ADDENDUM NUMBER SEVEN TO BIDDING DOCUMENTS

**NEW FIRE STATION – PUTNAM VALLEY FIRE STATION #1
OSCAWANA LAKE ROAD
PUTNAM VALLEY, NY 10579**

Date: March 25, 2021

DRAWING: PAVEMENT TYPE SKETCH

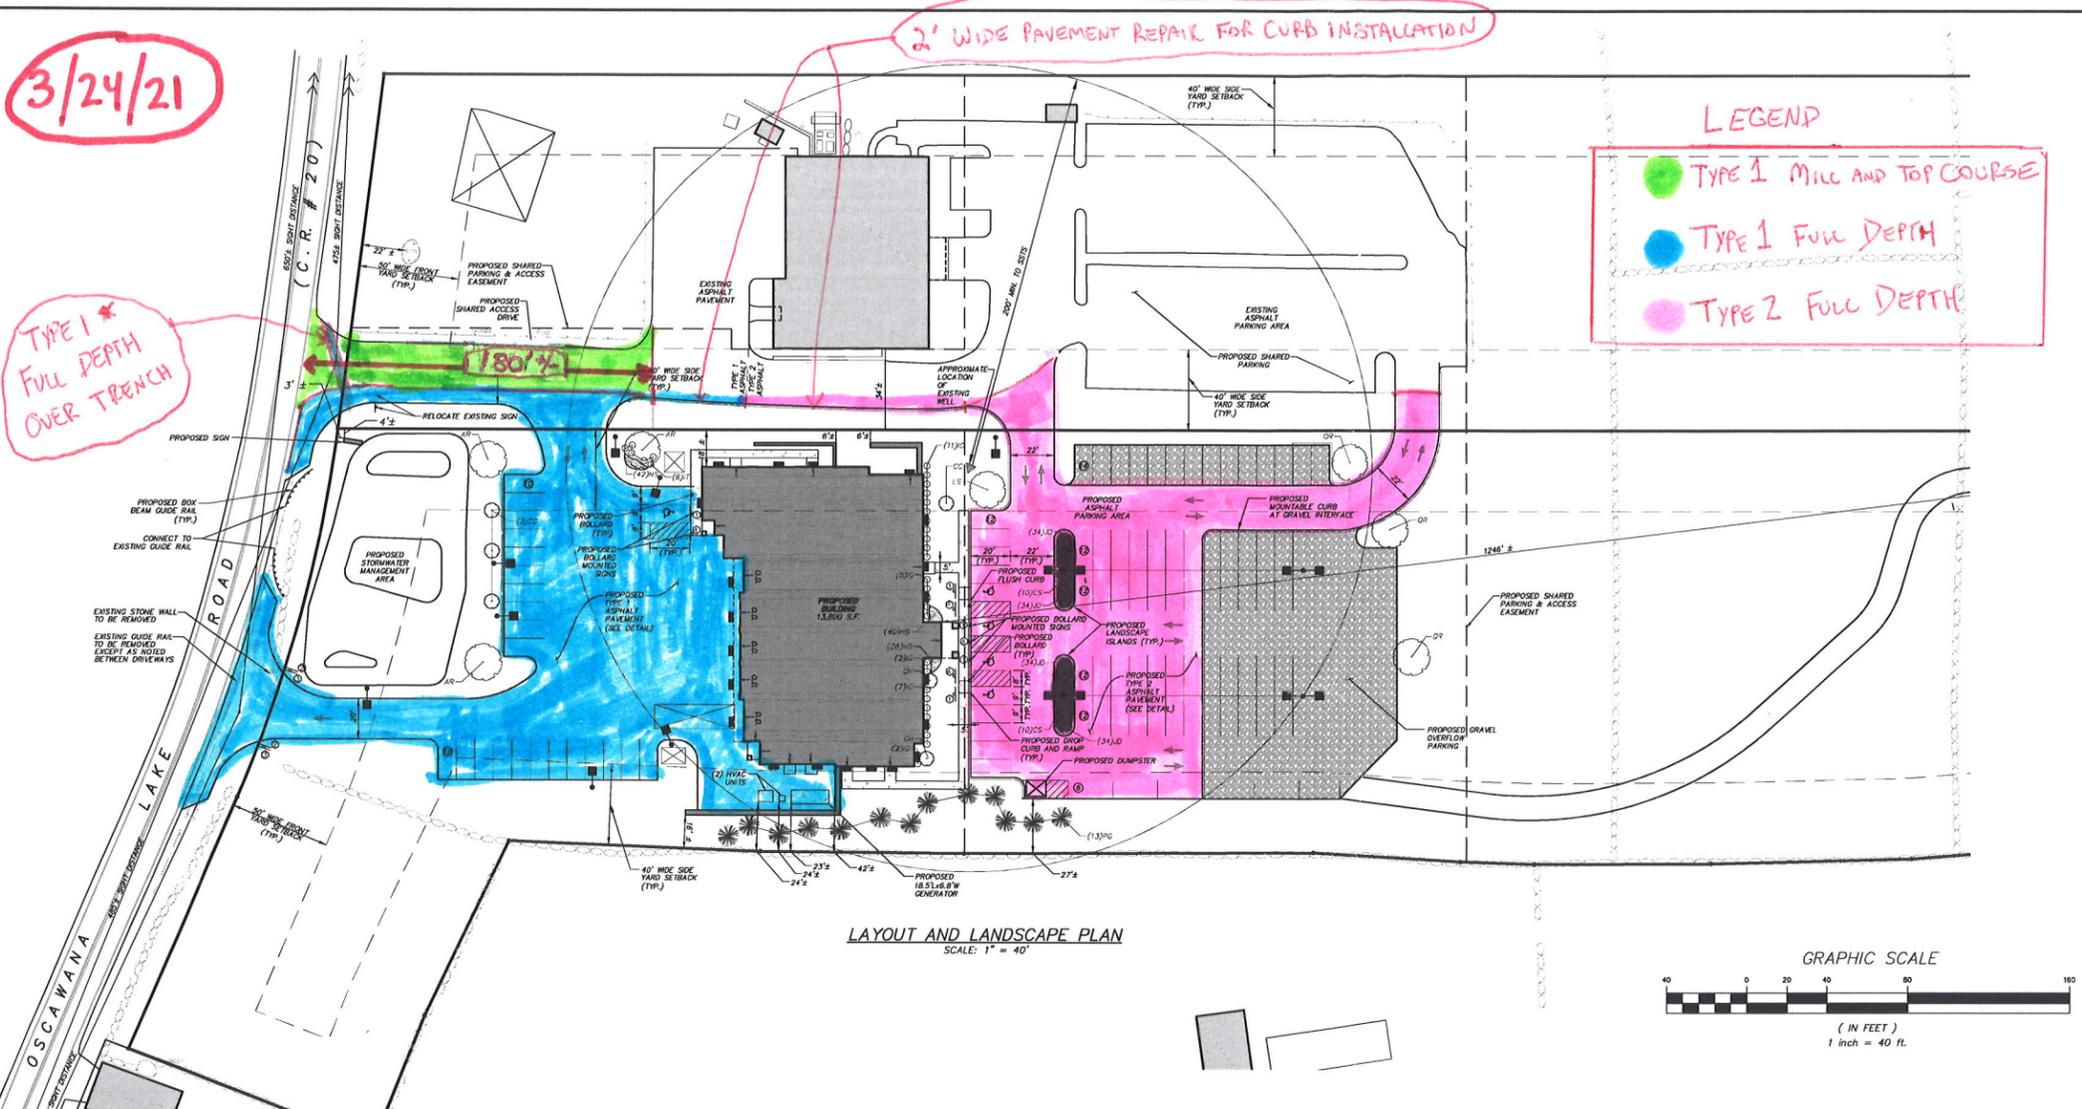
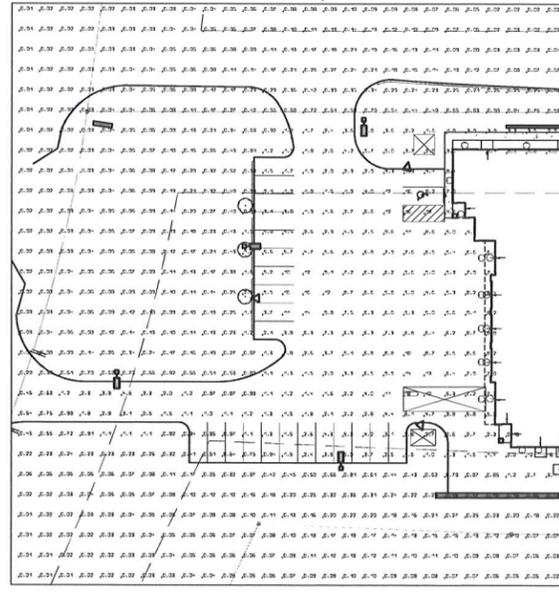
- A: The Main Relief Valve may be eliminated.
- Q: Please confirm the paving limits between the Fire Station site and the Ambulance Corp. site. Is the existing paving to be removed and replaced, milled and overlaid or the new paving just butted up to the existing paving?

- A: See attached sketch indicating the limits of new paving and the types of pavement to be installed. Refer to the legend on the sketch for the specific type of pavement install. As shown in the sketch, the existing driveway pavement on the Ambulance Corp. property shall be milled and top course asphalt installed (shown as green area) from Oscawana Lake Road to the 480 existing grade contour (which is approximately 180 feet). Also, it should be noted that the curb between the existing ambulance Corps building and the proposed fire station is a new curb and is part of the contract. The existing driveway on the Ambulance Corp. property shall be widened with full depth type 1 asphalt (shown as blue in sketch). The contractor is responsible for saw cutting pavement and patching pavement as part of curb installation. Also, at connections to the existing pavement, the contractor shall sawcut the pavement to full depth to provide a clean joint. All joints shall be hot sealed.
